## CITY OF CANTERBURY BANKSTOWN

## STORMWATER SYSTEM REPORT 88 Duke Street, CAMPSIE NSW 2194

Date: 02-Feb-2022 Ref: WP-SIA-163/2022

Development type: Residential Extension & Outbuilding / Pool

100yr ARI Flood Extent with flood contours to mAHD\*\*

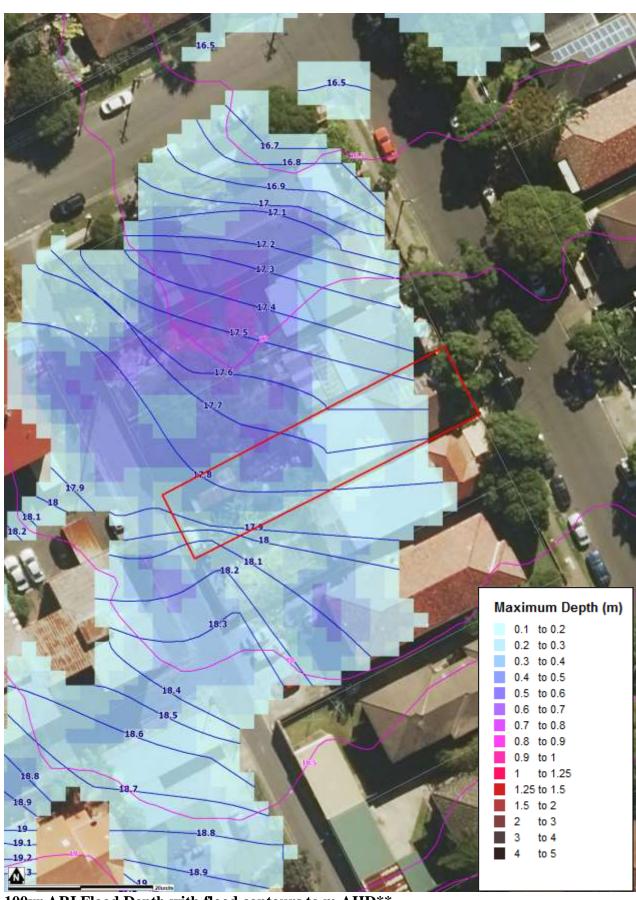
The site will be subject to stormwater inundation from this overland flowpath during large storm events. Refer to the attached "100 Year ARI Flood & PMF Extent Maps from Cooks River Overland Flow Catchment Study" showing the flood contours to m AHD\*\*. Provision should be made on site, and at boundary fences, for this stormwater runoff to pass unobstructed over the site. Stormwater flowing naturally onto the site must not be impeded or diverted.

Habitable floor levels are to be at least 500mm above the 100 year ARI\* flood level at the site adjacent to the proposed extensions or buildings.
